ZONING COMMISSION AGENDA

CASE# 1-23-Z

ZONE MAP AMENDMENT

Staff Report, Case# 1-23-Z:

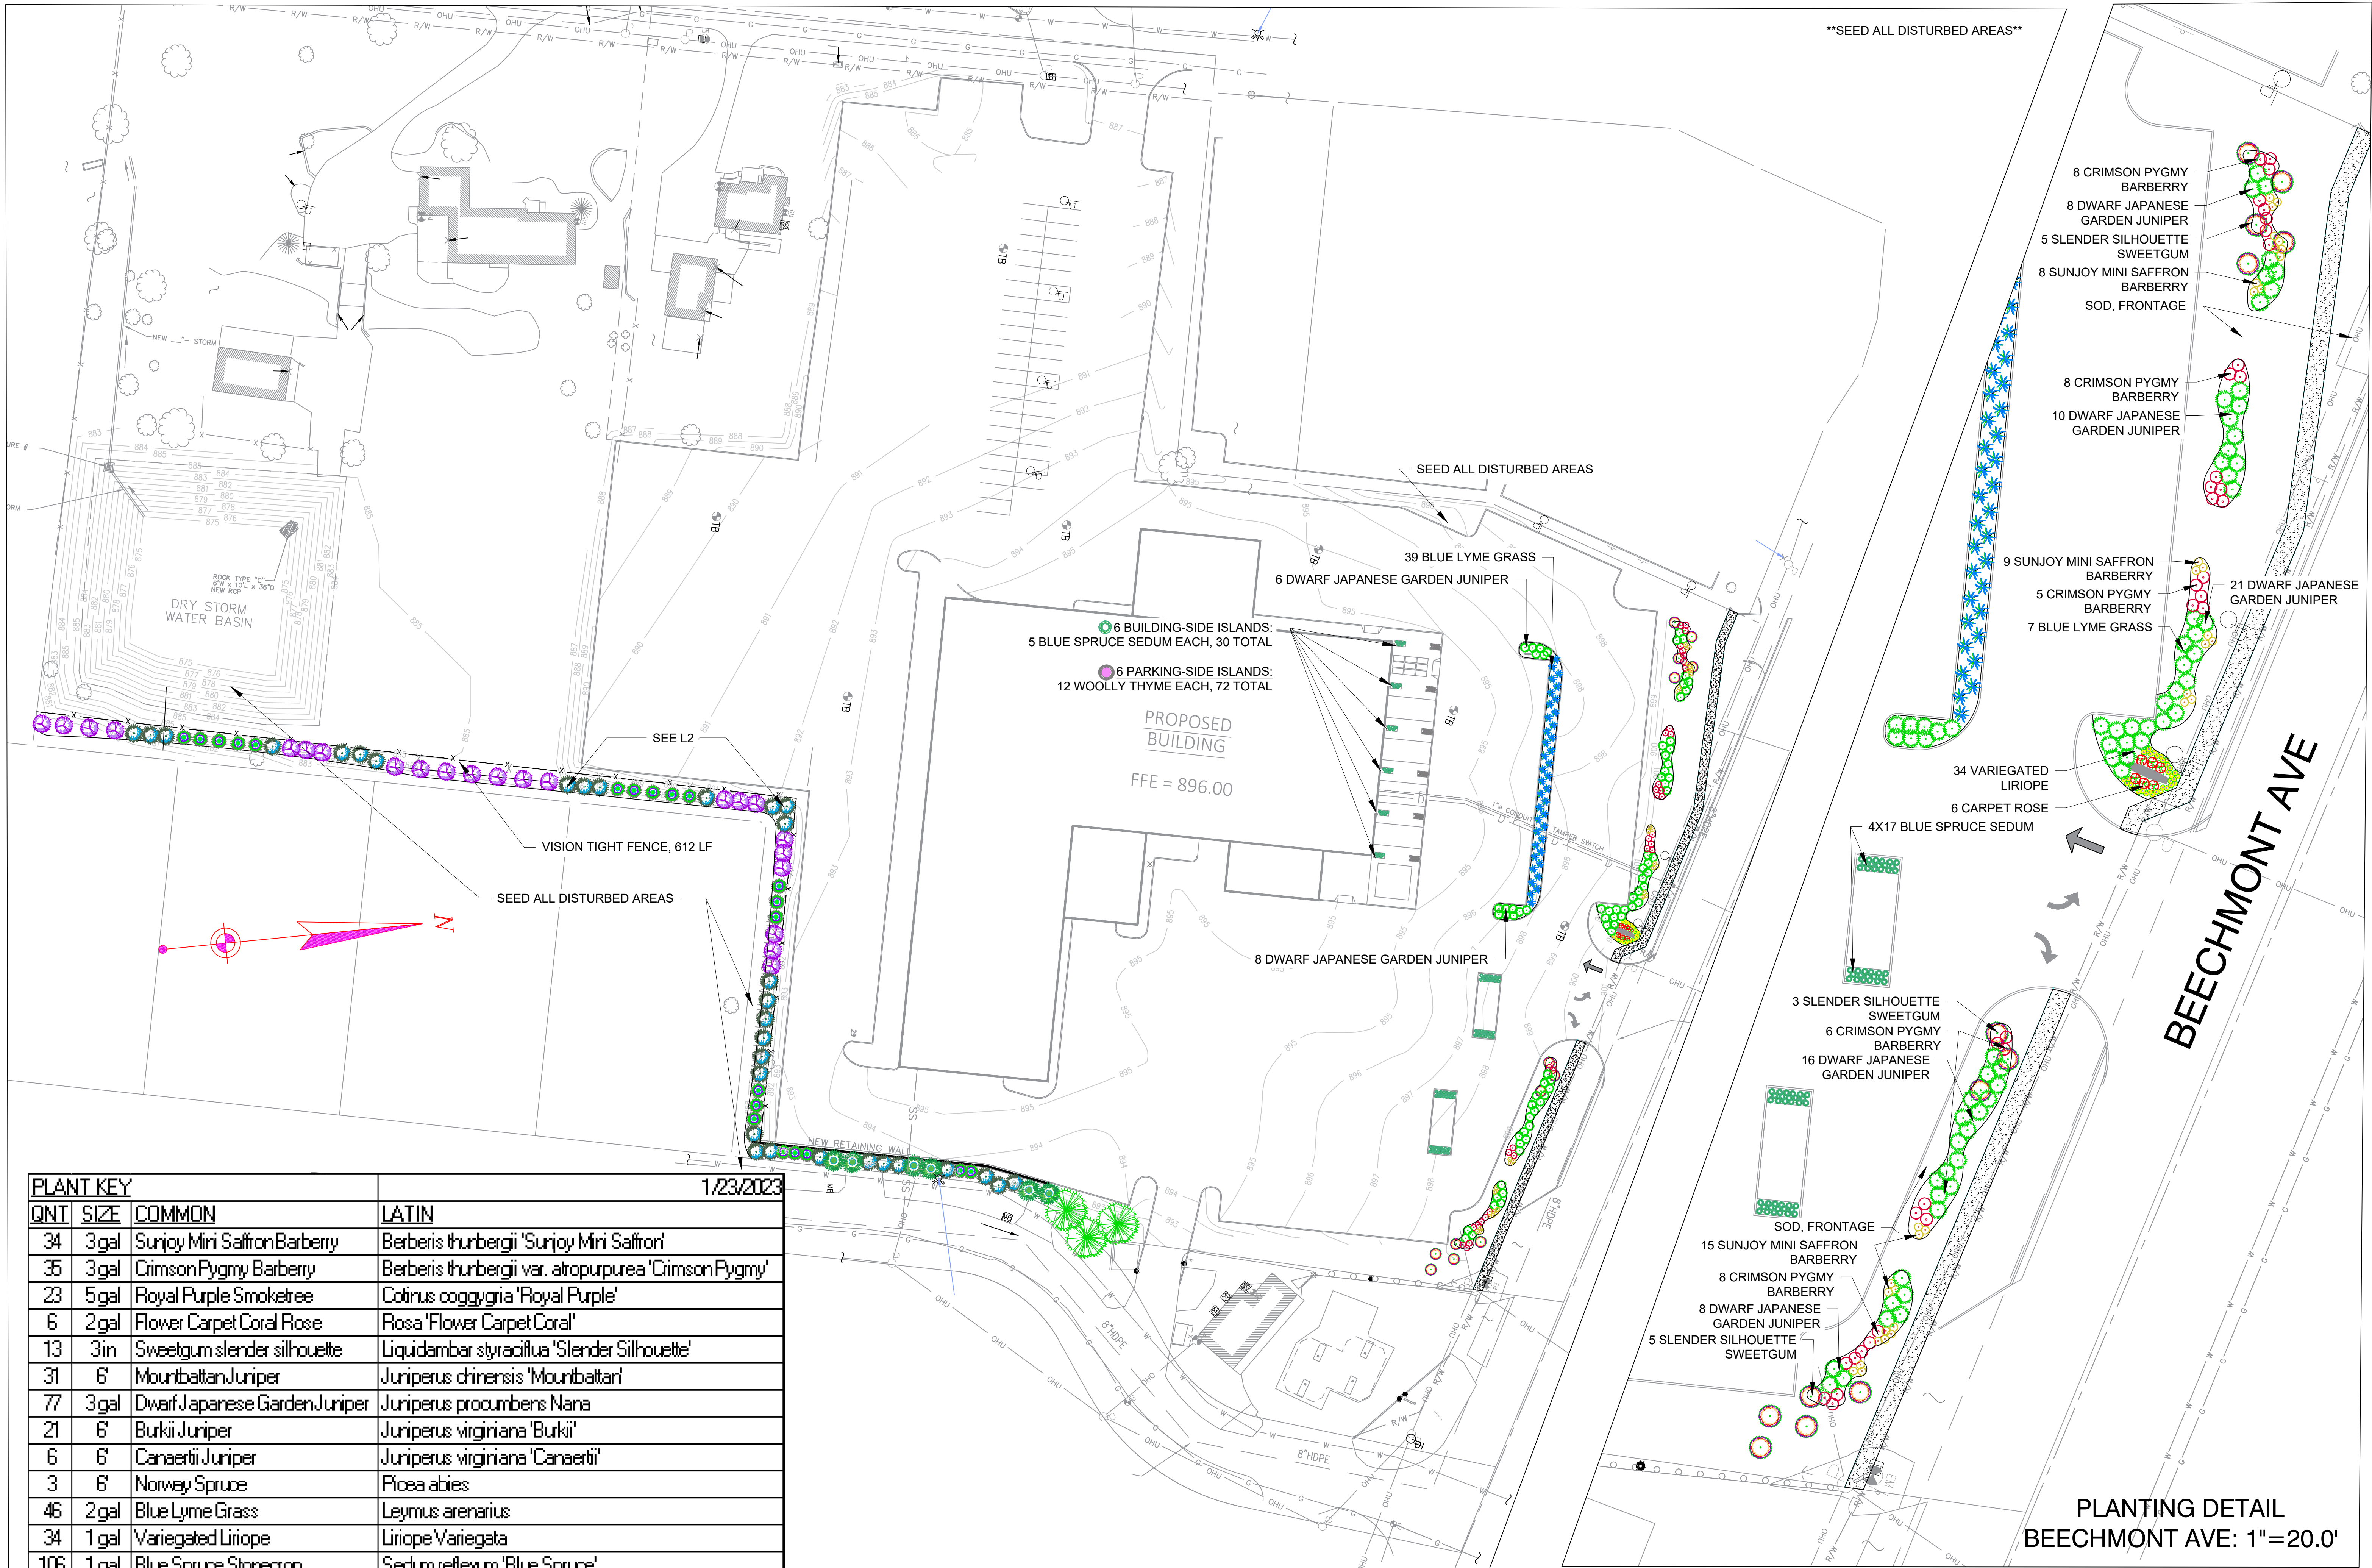
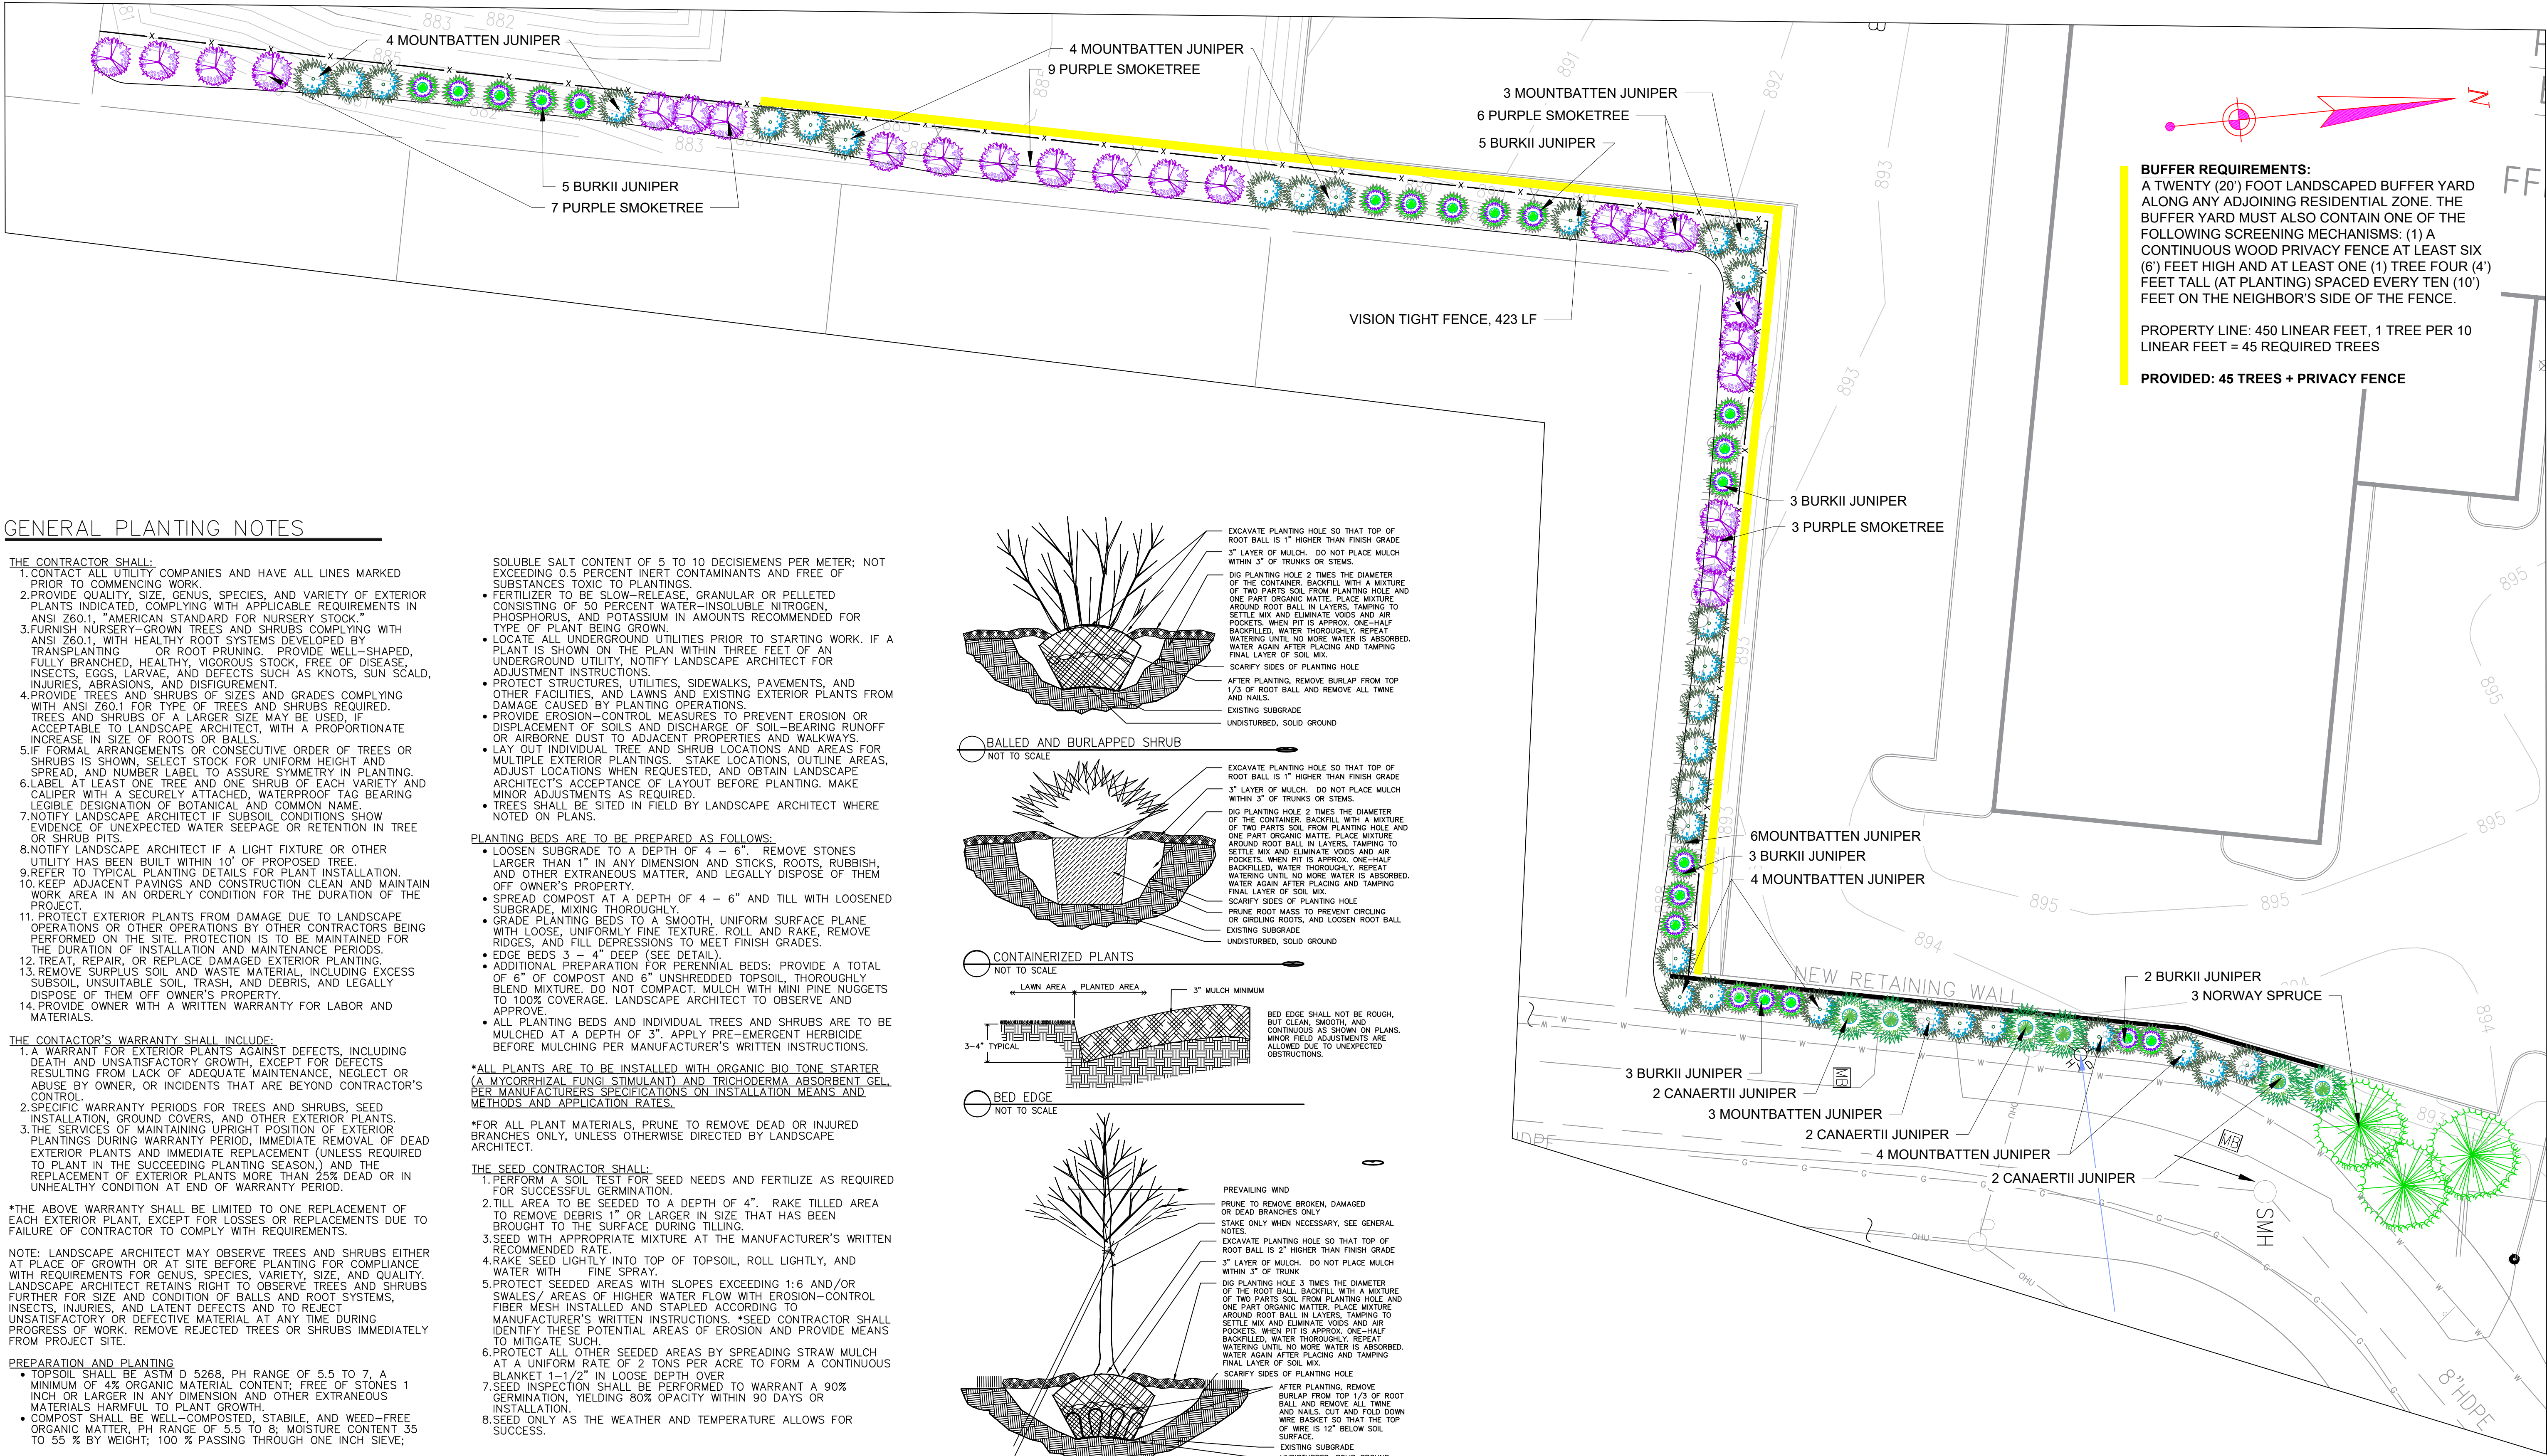
- 2) The Applicant would need to enhance the proposed landscaping and bufferyard areas along the western property line (between the future, new parking areas and the road) and also around the perimeter of the dumpster enclosure area. *All landscaping buffers should be marked as preservation areas, and any vegetation disturbed should be repaired, supplemented, or replaced.* This is an item that can be addressed administratively by staff.
